SEWAGE DISPOSAL SYSTEM

HOWARD COUNTY
BUREAU OF ENVIRONMENTAL HEALTH
992-2330

SUBDIVISION Jocelyn Acres ROAD 13405 Highland Road LOT 11, Sec. 3

A 32185

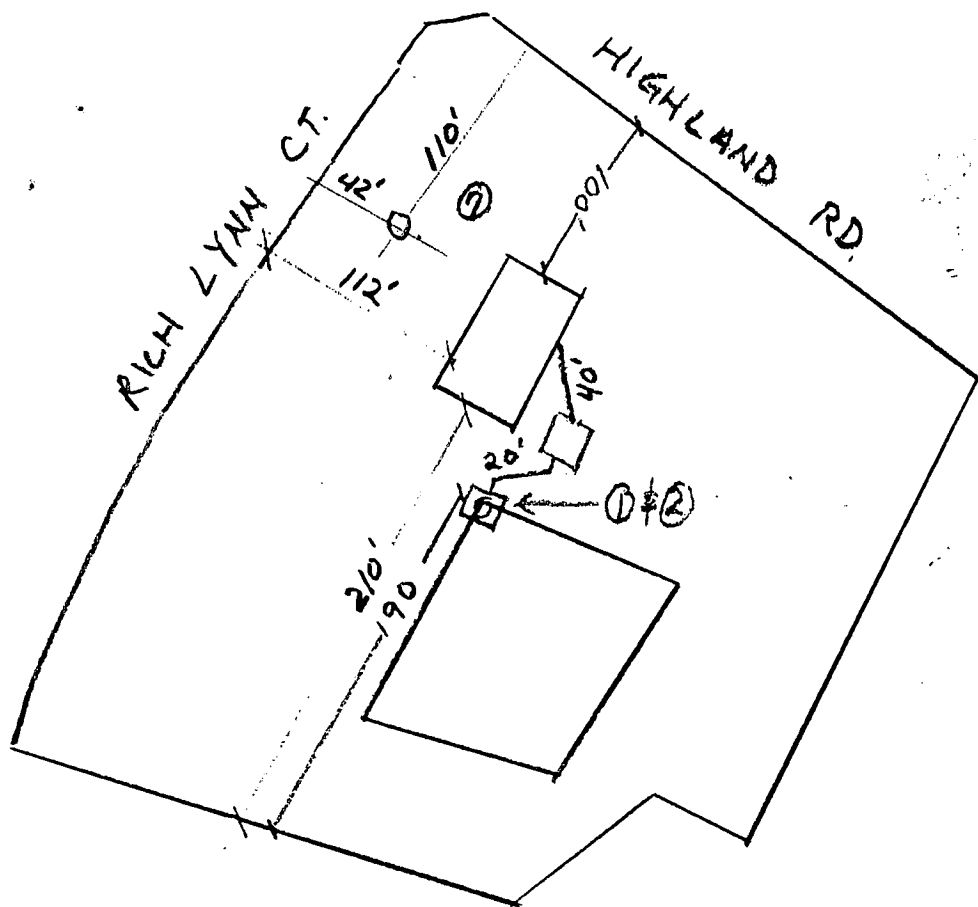
- ① ORIG. ELEV. AT TIME OF PERC 100.0
- ② EXIST. ELEV. 100.0
- ③ DISTRIBUTION BOX INVERT ELEV. 97.0
- ④ INVERT OUT OF SEPTIC TANK 97.8 EXIST. ELEV. 99.5
- ⑤ INVERT INTO SEPTIC TANK 98.05
- ⑥ INVERT OUT OF HOUSE 98.45
- ⑦ WELL ELEVATION 109.3
- ⑧ 1ST FLOOR ELEVATION. 104.0
- ⑨ BASEMENT ELEVATION 95.25

5/2/84
 Sketch OK.
 J.S.

BP 50938
113405 Rich Lynn Ct
EXISTING B.R.

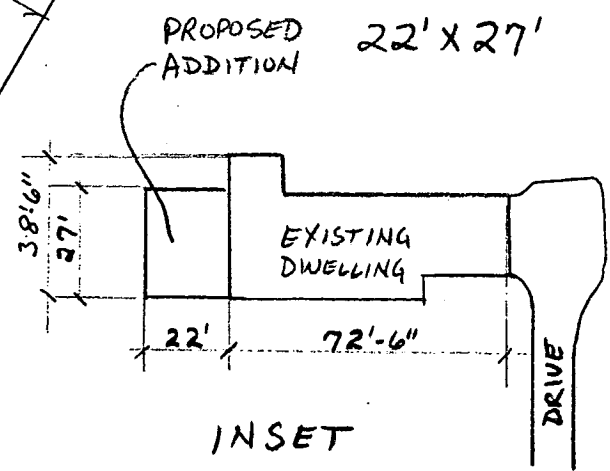
9/14/88
OK to sign PJ

B 50938

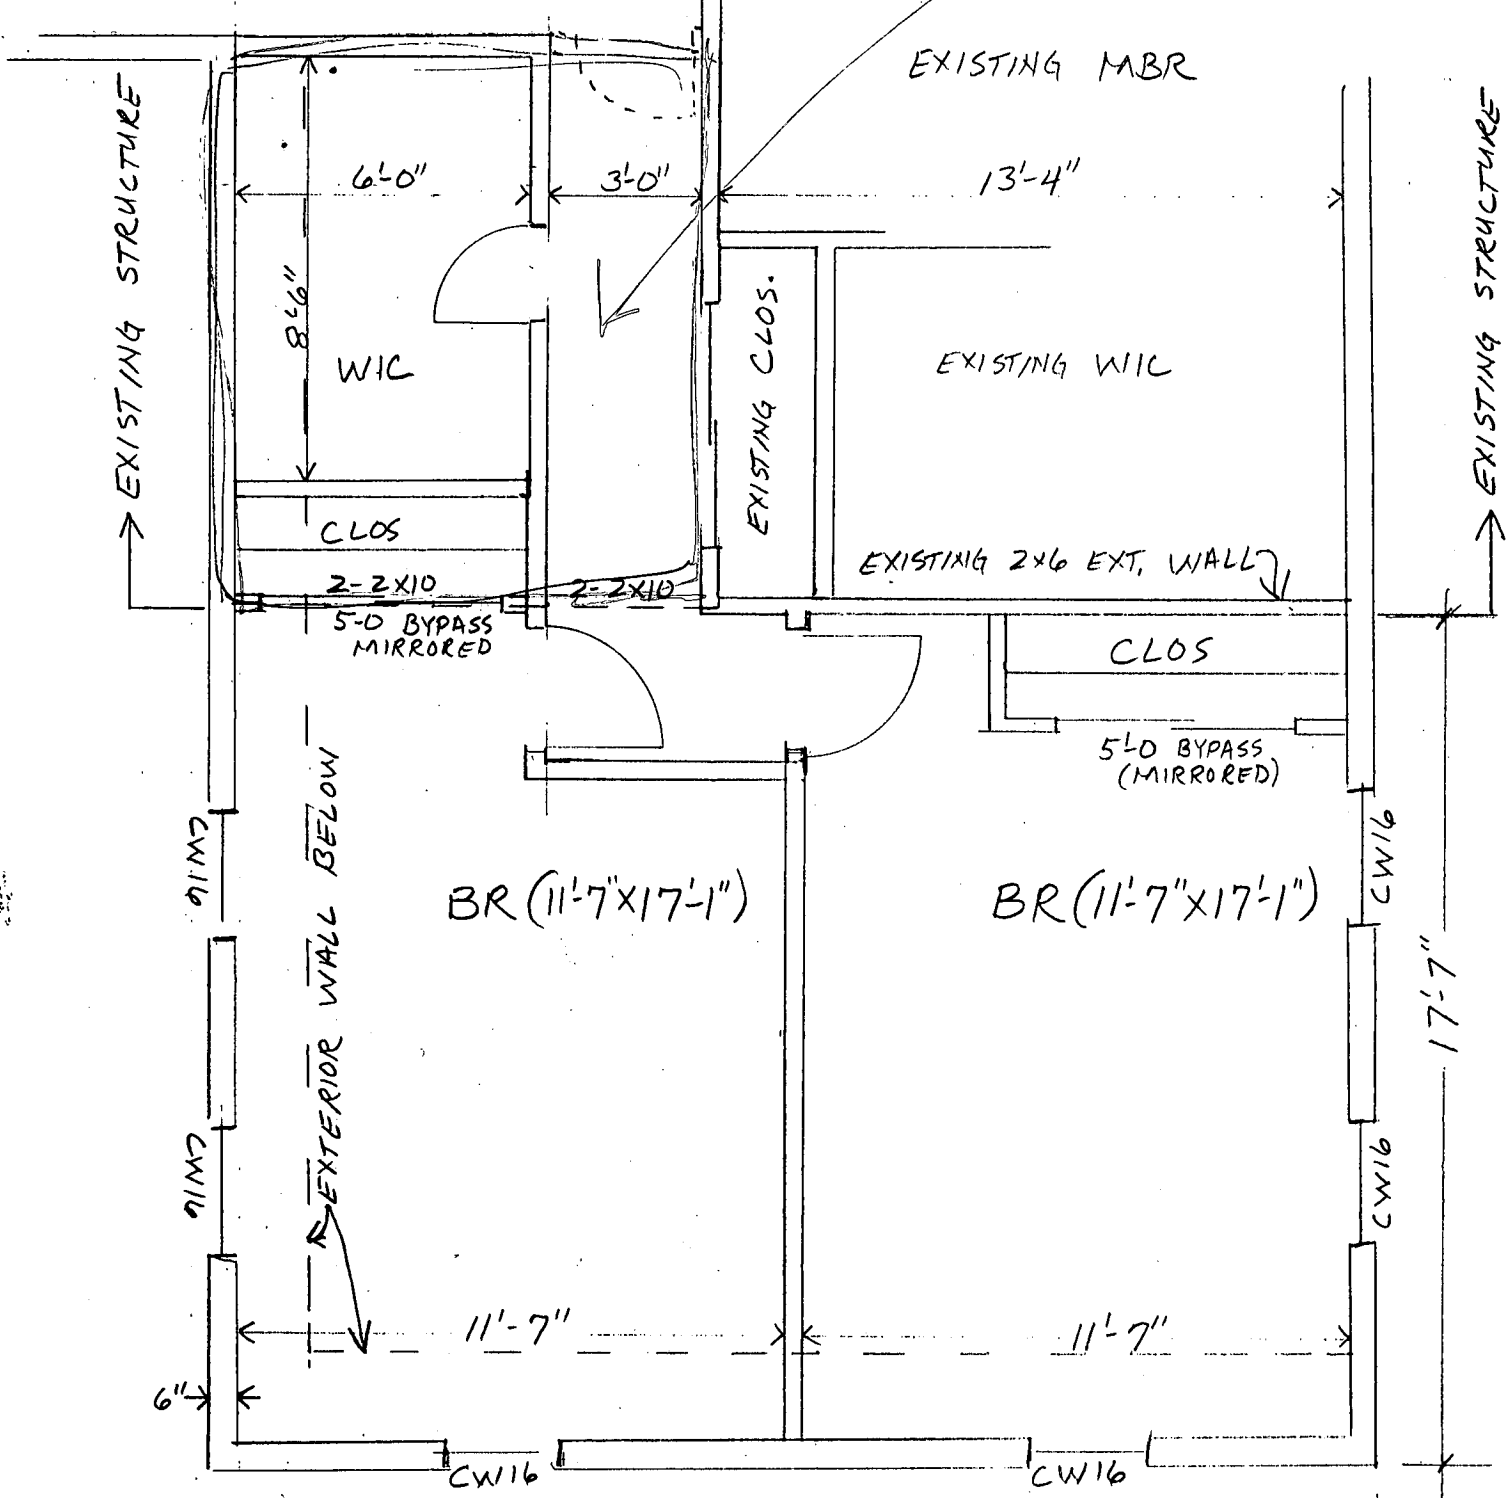
REMOVE EXISTING DOORWAY

10/29/93 This plan shows One of Bedrooms in house is to be converted to walk in closet & two bedrooms to be installed in garage After construction there will be 4 bedrooms hooked up to the old system
WARSHOWSKY ADDITION
 FRAME 2 BR'S OVER EXISTING GARAGE
 CONVERT EXISTING BR. TO HALL & CLOSERS
 OK TO SIGN R/H

HIGHLAND ROAD

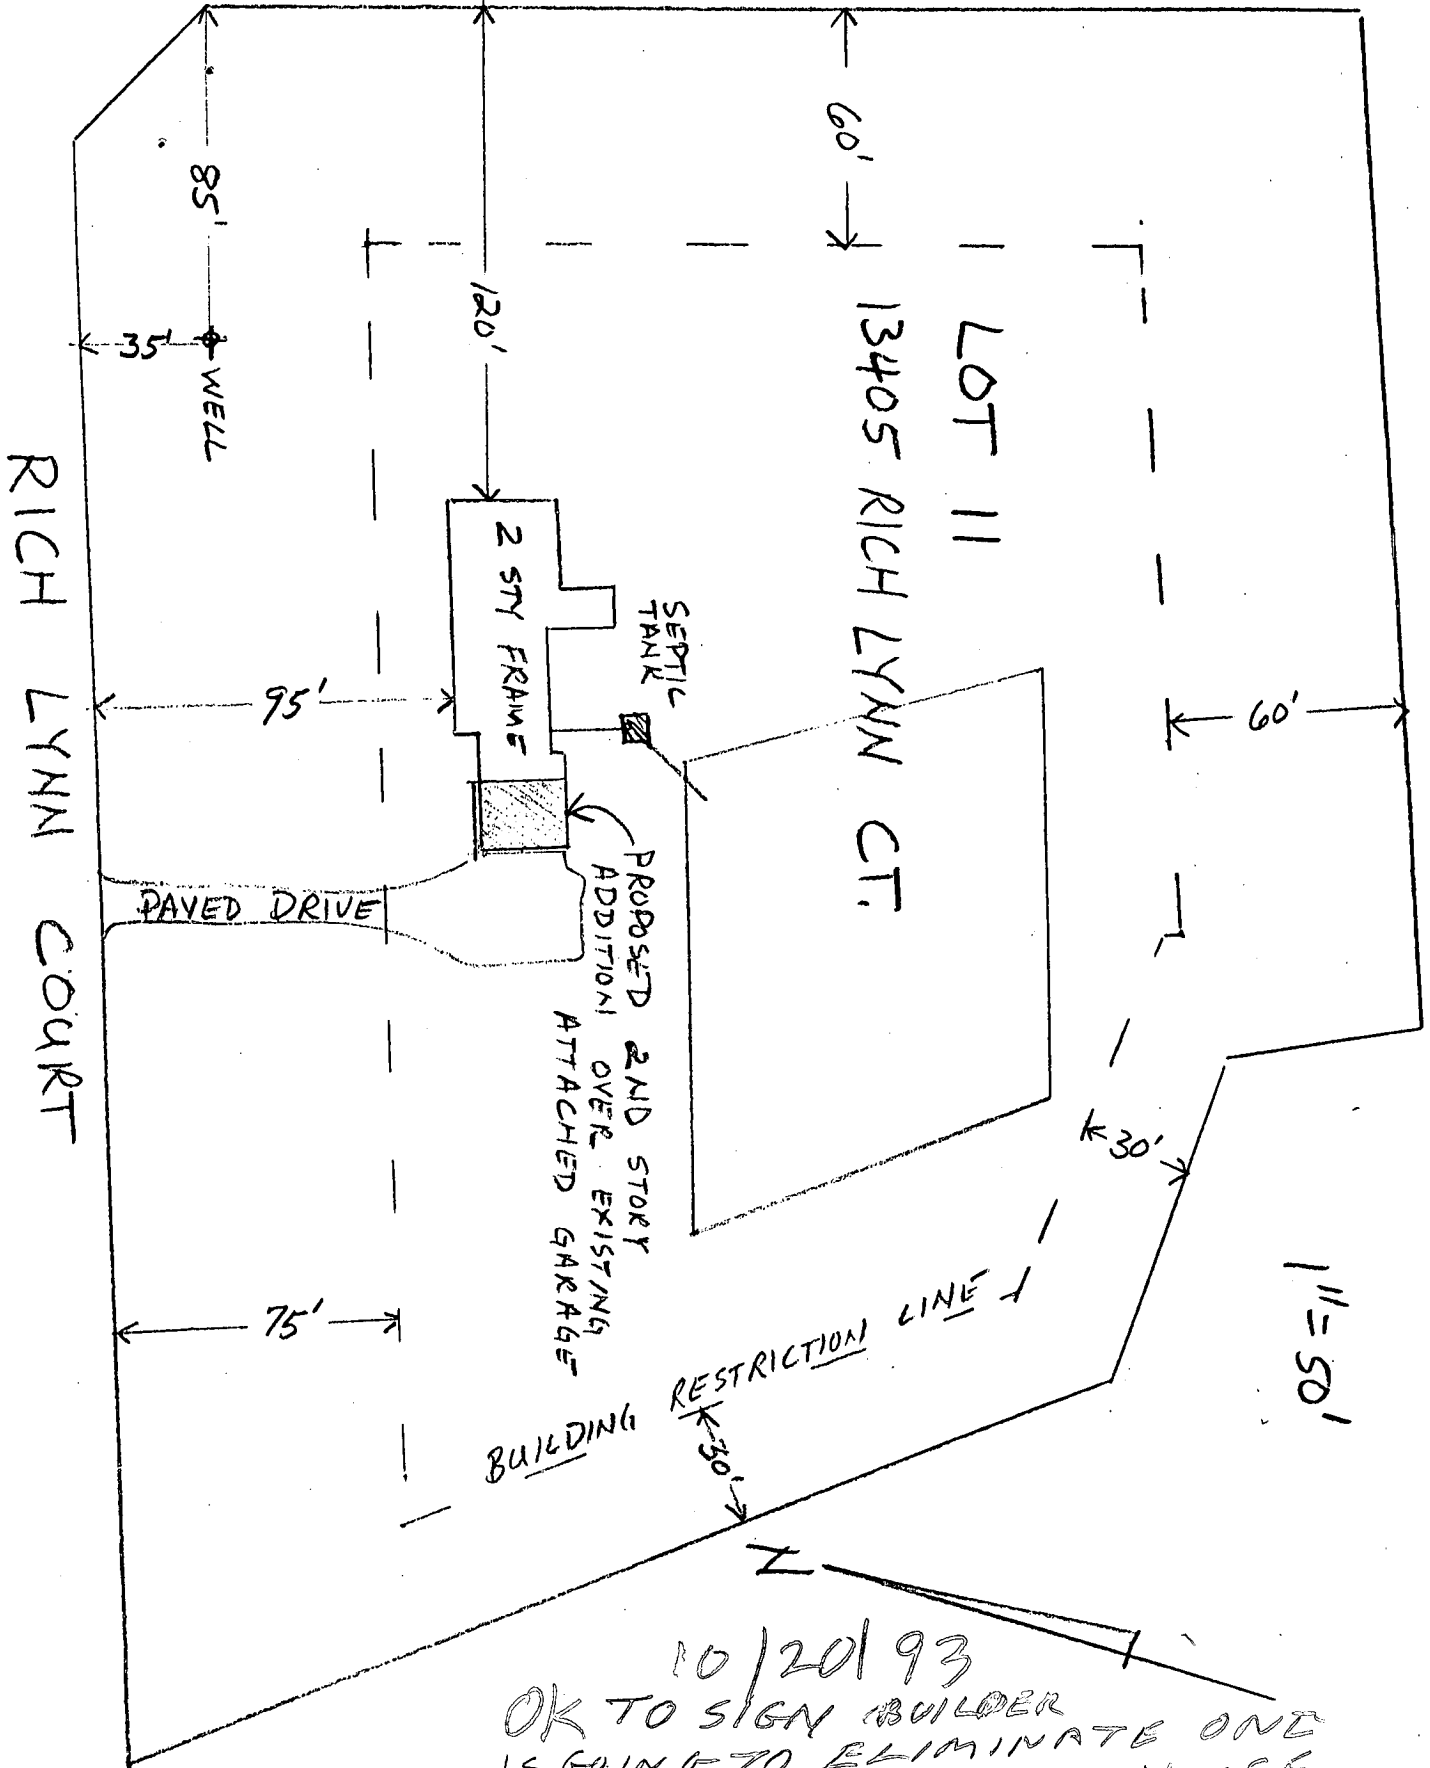
10/20/93
 OK TO SIGN BUILDER
 IS GOING TO ELIMINATE ONE
 BED ROOM IN THE OLD HOUSE
 SEE OTHER PLAN R/H
